Docket No. 50-336

Millstone Nuclear Power Station, Unit No. 2
Mitigation of CEA Guide Tube Wear, Cycle 4

MITIGATION OF CEA GUIDE TUBE WEAR, CYCLE 4

FIGURE 2

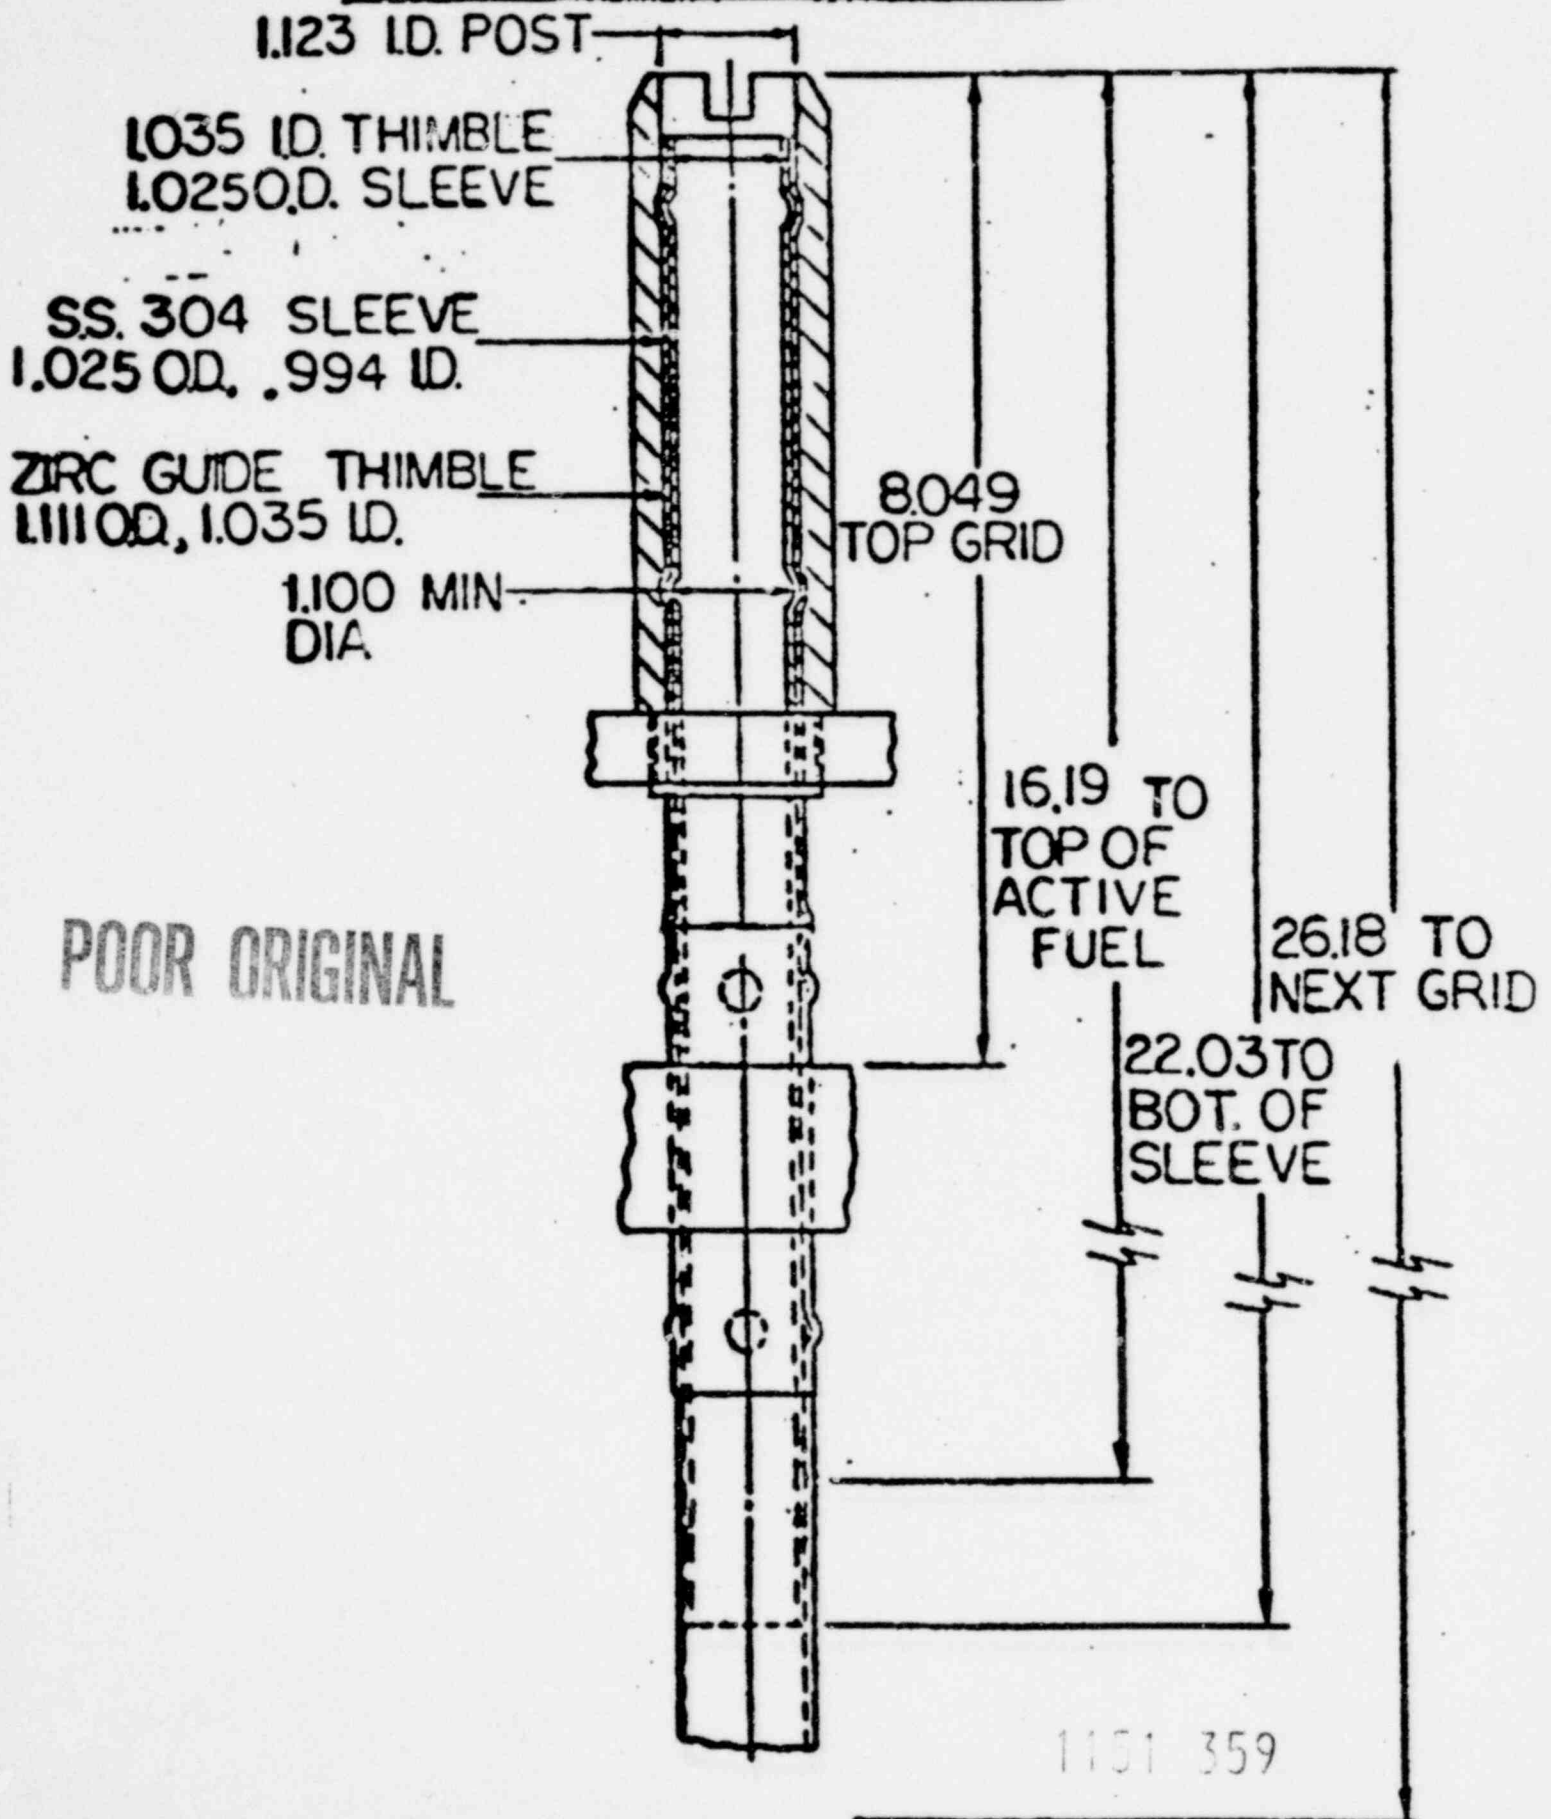
Attachment of the sleeve to the fuel assembly is made by expanding the upper portion of the sleeve into the zircaloy guide tube at two (2) swage groove locations provided in the top nozzle extensions. This method of attachment, illustrated in Figure 2, utilizes existing features present in the fuel design and is an extension of the expansion joint technology presently in use by the vendor.

FIGURE 3

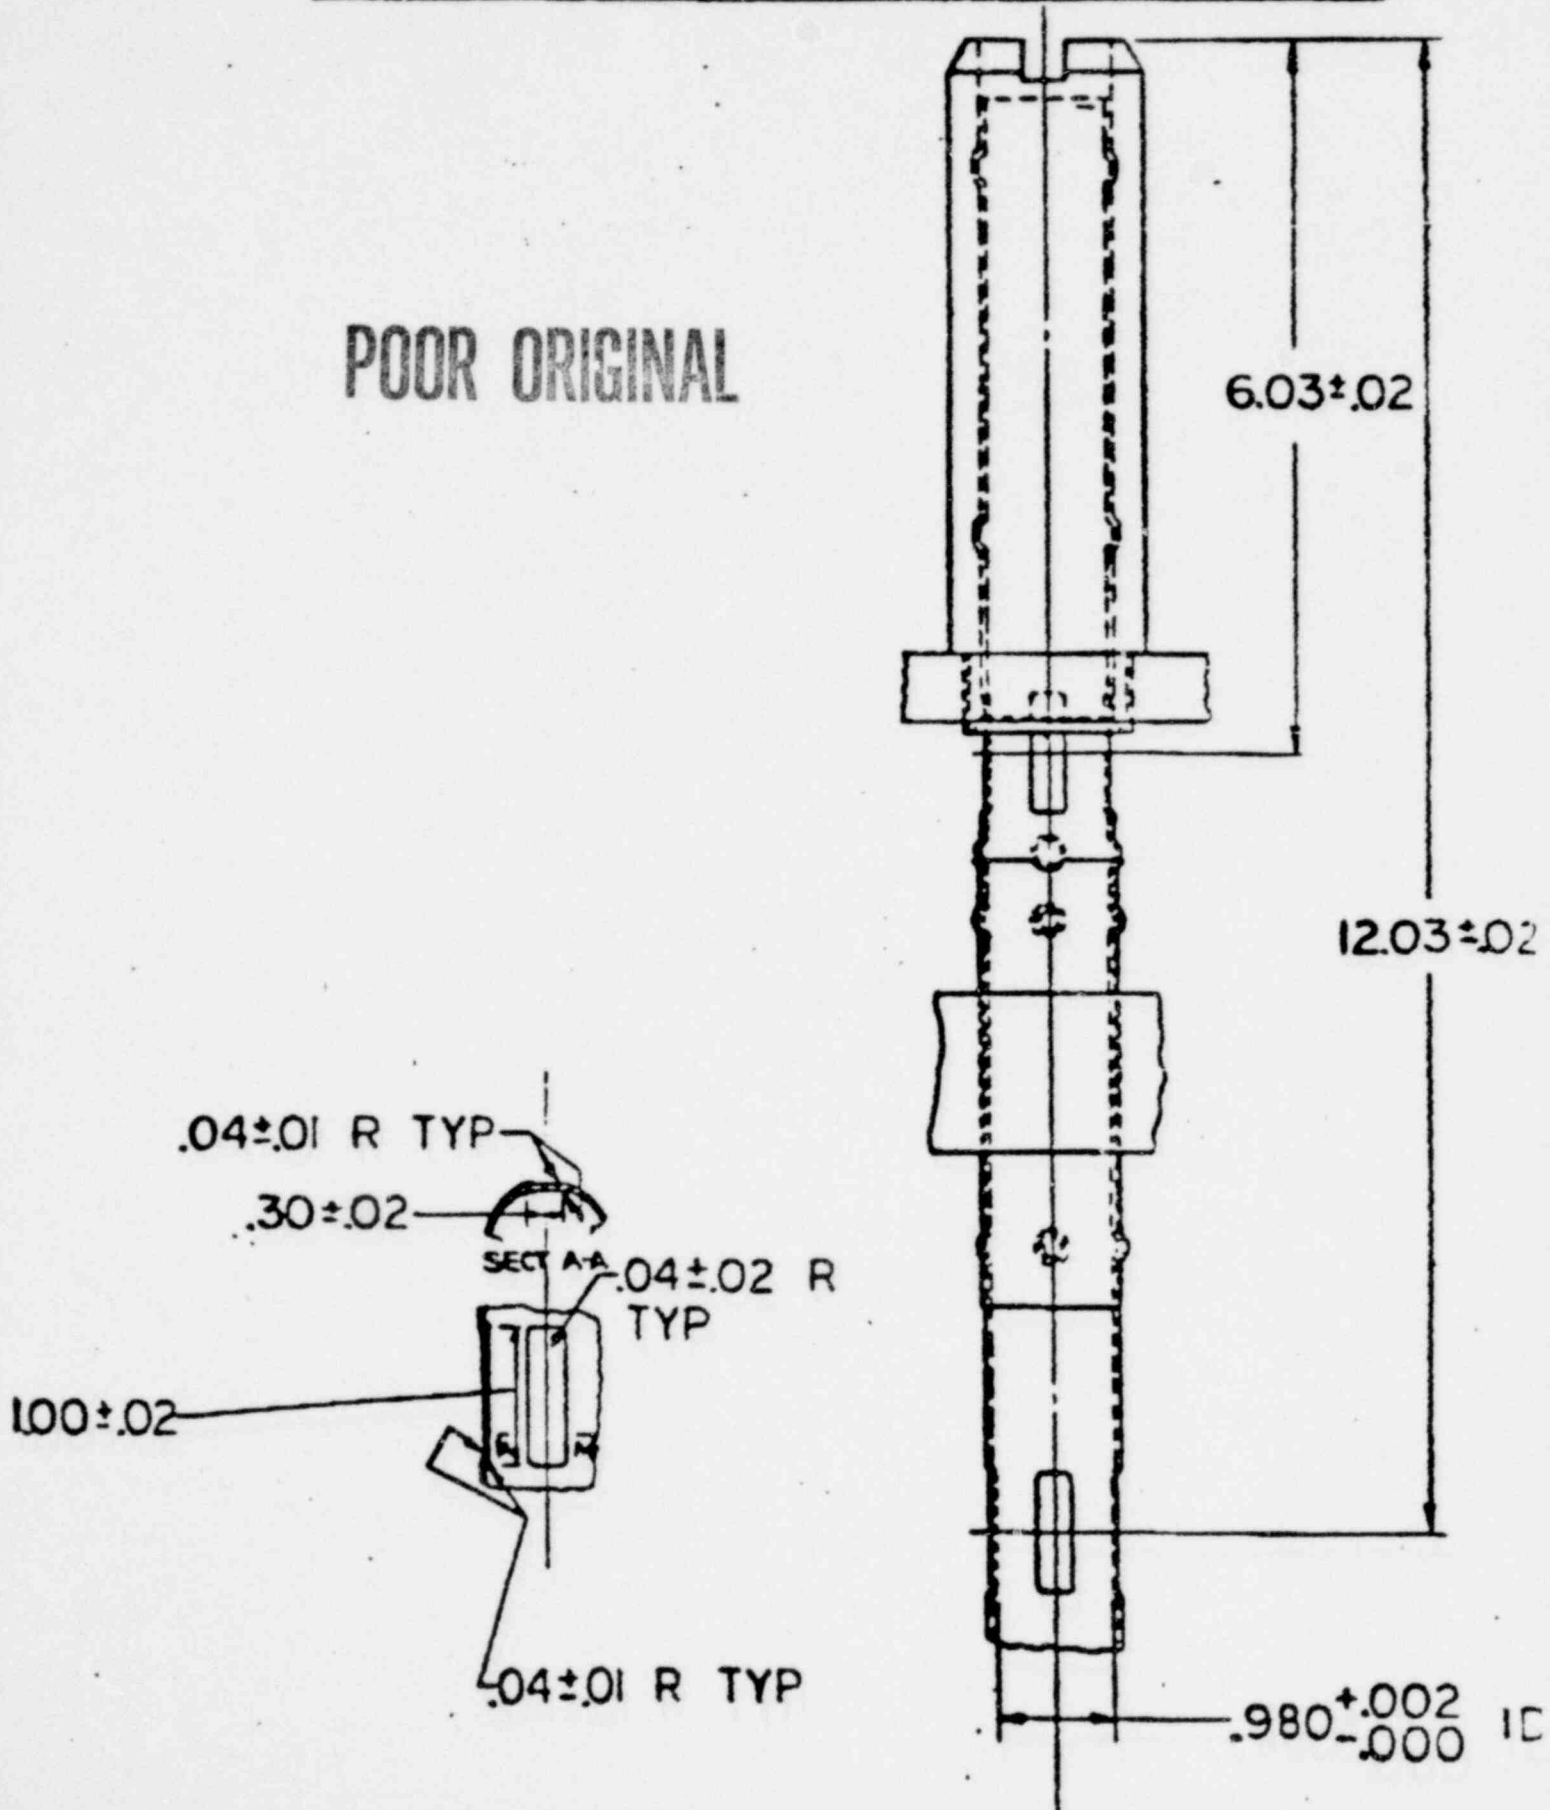
As part of a longer range design change to mitigate guide tube wear, NNECO proposes the following inset design, illustrated in Figure 3. The inset design consists of a structural modification made to the fuel assembly guide tubes that is intended to greatly reduce the wearing condition by standing-off

the tip of the control rod from the guide tube wall, thereby reducing the amplitude of rod vibration. These insets are 1.00 inch long by 0.30 inch wide rectangular deformations that reduce the original tube diameter locally from 1.035 inch to 0.980 inch. Four individual insets are located at two axial elevations of the guide tubes.

Results of initial tests performed to date demonstrate that the inset design provides advantages over the existing sleeve design. A four assembly demonstration program utilizing the inset design is planned for Cycle 4. The performance of the insets will be assessed by comparing boroscopic examinations to establish visual wear standards. Inspection techniques and needs will be further evaluated for both the sleeve and inset designs.
